### Addendum 45: Regulation No. 46

#### Revision 4 – Amendment 1

Supplement 1 to the 03 series of amendments - Date of entry into force: 18 November 2012

**Uniform provisions concerning the approval of devices for indirect vision and of motor vehicles with regard to the installation of these devices**

Figure 1

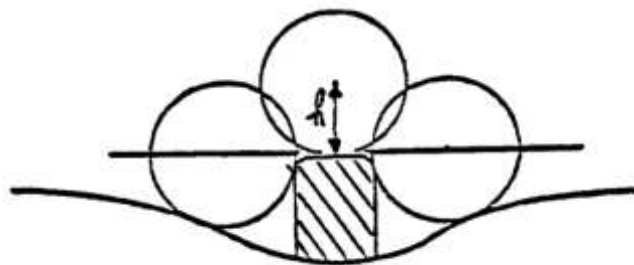
Insert new paragraphs 6.1.1.4. to 6.1.1.4.2., to read (including a new Figure 1):

- 6.1.1.4.2. If the dimension of the projection of a component which is mounted on a surface other than convex cannot be determined by simple measurement, it shall be determined by the maximum variation of the distance of the centre of a 100 mm diameter sphere from the nominal line of the panel when the sphere is moved over and is in constant contact with that component. Figure 1 shows an example of the use of this procedure.

- "6.1.1.4. The requirements in paragraphs 6.1.1.2. and 6.1.1.3. shall not apply to parts of the external surface which protrude less than 5 mm, but the outward facing angles of such parts shall be blunted, save where such parts protrude less than 1.5 mm. For determining the dimension of the projection, the following method shall apply:

- 6.1.1.4.1. The dimension of the projection of a component which is mounted on a convex surface may be determined either directly or by reference to a drawing of an appropriate section of this component in its installed condition.
